*Amndt. 104  
to DPR-37*

Docket Nos. 50-280  
and 50-281

These amendments revise the Technical Specifications to reflect changes to the VEPCO offsite and the Surry Power Station organizations, and revise the immediate notification requirements and the Licensee Event Reporting System to be consistent with Sections 50.72 and 50.73 of 10 CFR Part 50.

SURRY POWER STATION, UNIT NO. 1

T.S. Fig. 6.1-1

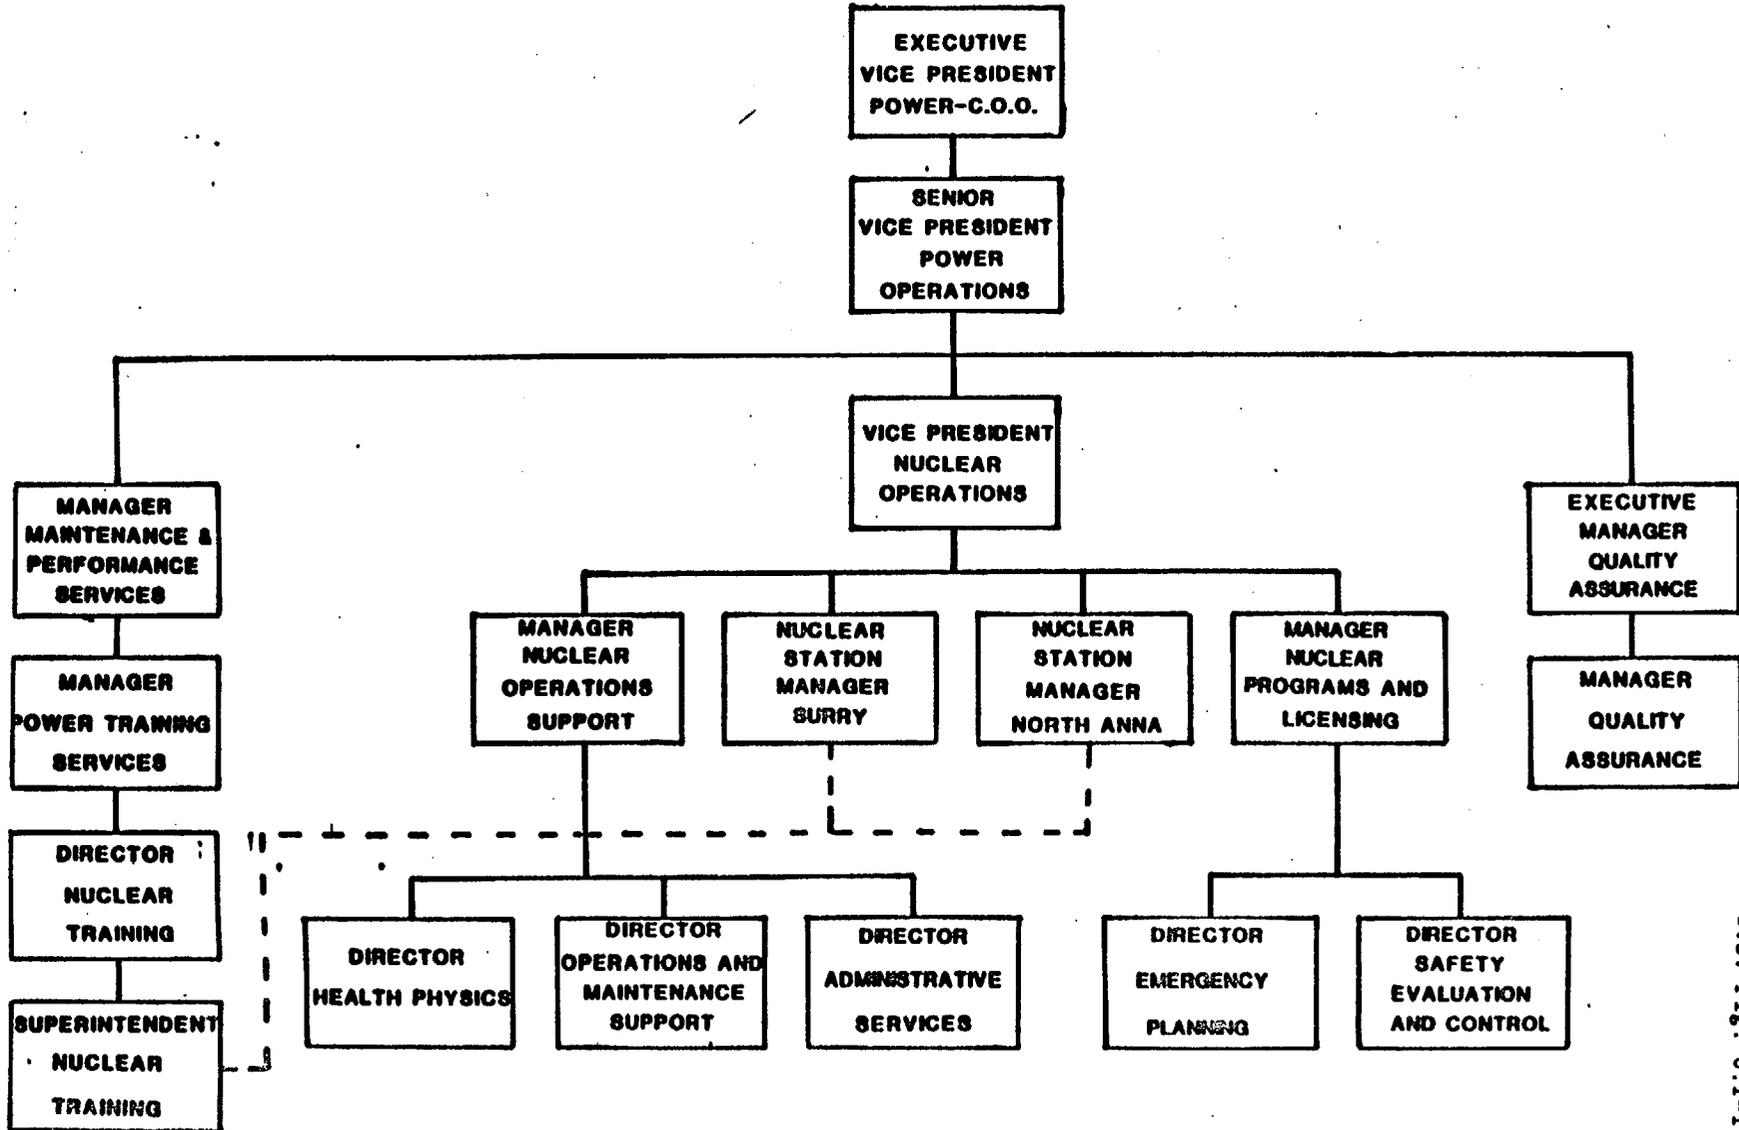
We have reviewed the proposed changes and find them acceptable as they meet the acceptance criteria of Sections 13.1.1, 13.1.2, and 13.4 of NUREG-0800, the Standard Review Plan. Technical Specification Figures 6.1-1 and 6.1-2, as revised, show the reorganized offsite and onsite management organizations.

- A. The Station Manager shall be responsible for the overall operation of the facility. In his absence, the Assistant Station Manager (Operations and Maintenance) shall be responsible for the safe operation of the facility. During the absence of both, the Station Manager will delegate in writing the succession to this responsibility.
  1. The off-site organization for facility management and technical support shall be as shown on TS Figure 6.1-1.
